STAFF RECOMMENDATION
1612 Douglas Avenue
May 15, 2019

Application: New Construction—Infill and Outbuilding
District: Eastwood Neighborhood Conservation Zoning Overlay
Council District: 06
Base Zoning: R6
Map and Parcel Number: 08302018600
Applicant: Brad Sayers, Four Square Design Studio
Project Lead: Jenny Warren, jenny.warren@nashville.gov

Description of Project: The applicant proposes to construct a new duplex and outbuilding.

Figure 3: Proposed front elevation.

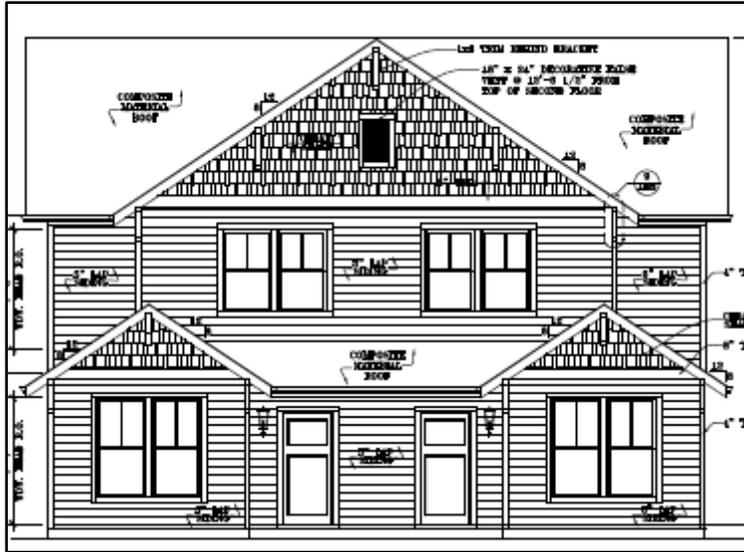
Height & Scale: The historic context consists of one and one-and-a-half story houses that range in height between twenty feet and twenty seven feet (20'-27'). The proposed duplex is a true two-story and will have a total height of twenty-nine feet, two inches (29'-2"), with an eave height of about eighteen feet (18'). Staff finds that the proposed two-story, twenty-nine foot (29') high duplex is inappropriate for the historic context.

Historic houses in the surrounding area are typically between twenty-eight feet (28') and thirty-two feet (32') in width, the proposed house is about thirty-nine feet, six inches (39'6") wide. For context, the contributing house immediately next door at 1610 Douglas Avenue is twenty-nine feet (29') wide. (Figure 4) The proposed house would be more than ten feet (10') wider.

Given the two-story form, the proposed height and the proposed width, staff finds that the proposed new construction is not compatible with the historic context and does not meet Sections II.B.1.a. and II.B.1.b. of the design guidelines.

Figure 6: Side elevation – note the shallow roof slope. Arrows indicate locations where windows should be added.

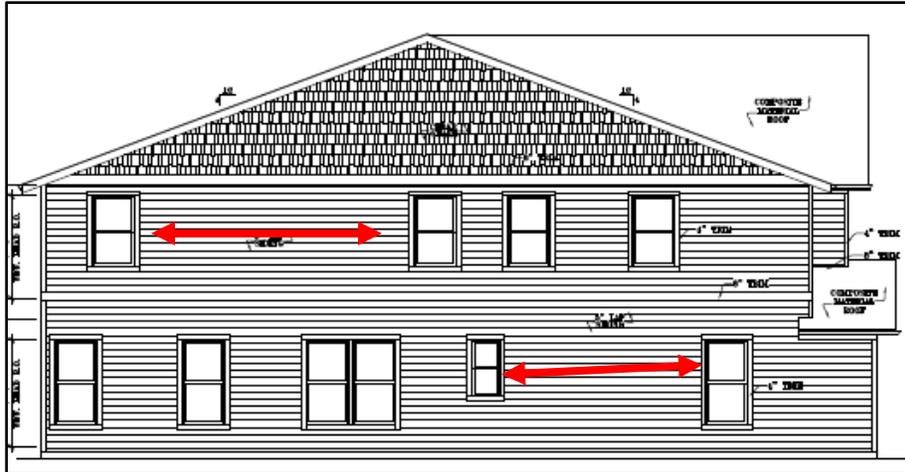
The 8/12 gabled roof form is appropriate for the context, however the 4/12 slope is flatter than is typical for the historic context. (Figure 6) Staff questions the appropriateness of this roof slope.

Proportion and Rhythm of Openings: The majority of window and door openings on the new building will be generally twice as tall as they are wide, as is typical of the proportions of openings on historic buildings. The side elevations both have two wall expanses of more than thirteen feet (13') with no window openings. (Figure 6) Staff recommends that windows be added in these locations.

Staff finds that with the addition of window openings on the side elevations, the window proportions and rhythms are generally compatible with the surrounding area and that the project will meet section II.B.1.g. of the design guidelines.

PLOT PLAN

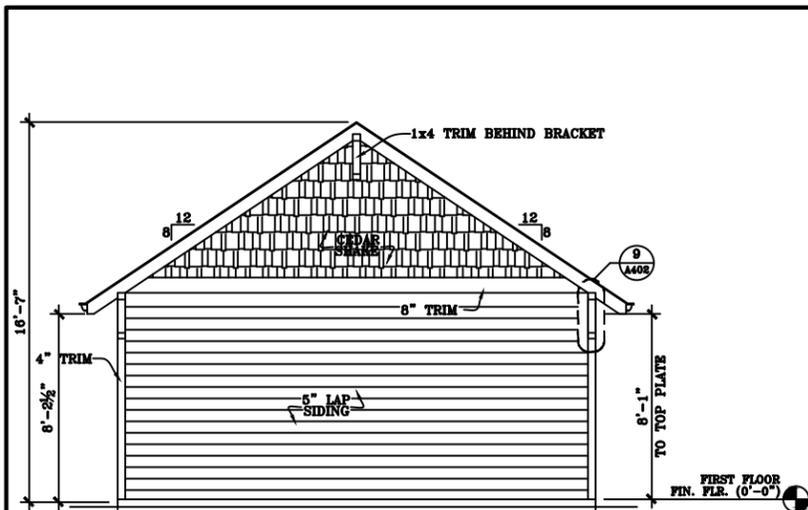
Setback & Rhythm of Spacing: The front wall of the proposed new construction sits about forty feet (40') from the front property line. (Figure 5) The historic houses on

either side sit about thirty-three to thirty-five feet (33'-35') from the property line. Staff recommends that the front setback be moved up, in line with the historic houses. As is the case for all infill applications, staff would ask to verify the front setback on site at the start of construction.

The side setbacks are proposed to be five feet (5') on both sides. This meets the base zoning requirements, but as noted above creates a house that is too wide for the historic context, and disrupts the historic rhythm of spacing on the street. The rear of the house is more than fifty-five feet (55') from the rear property line.

Due to the deep setback and the out-of-character width of the proposed structure, staff finds that as proposed, it is not compatible with section II.B.1.c of the design guidelines.

Appurtenances & Utilities: The location of the HVAC units is not shown on the site plan. Staff recommends that these be located along the rear elevation, or on a side elevation, beyond the midpoint.

FRONT ELEVATION
SCALE: 1/8" = 1'-0"

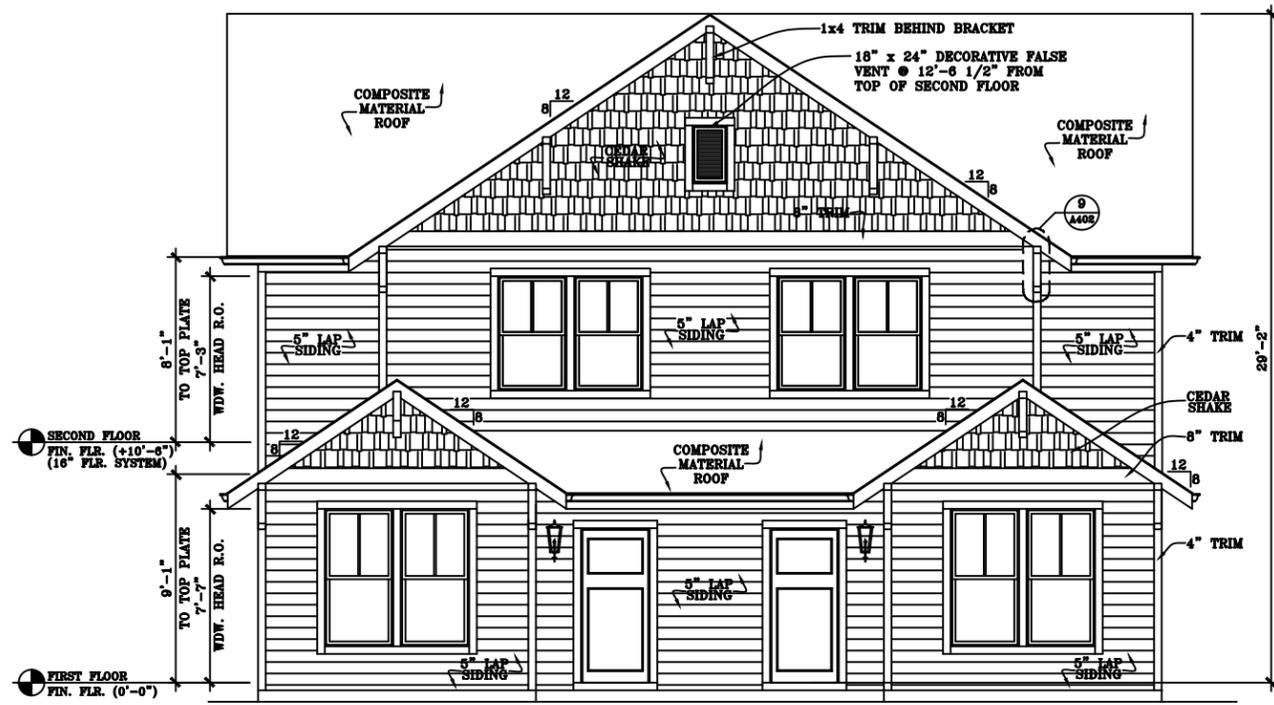
Orientation: The front of the new duplex faces onto Douglas Avenue and is compatible with the orientation of historic houses in the surrounding area. The site plan shows that two central doors will be recessed about two feet, nine inches (2'9") from the projecting front gables and covered with a shed roof. The guidelines state that new construction should include a front porch, at least six feet (6') deep, which this proposal does not provide. The site plan indicates a walkway from the front doors to the street, which is appropriate.

Staff finds that the orientation toward Douglas Avenue with a walkway to the street is appropriate but that a porch, at least six feet (6') deep should be added in order to meet section II.B.1.f of the design guidelines.
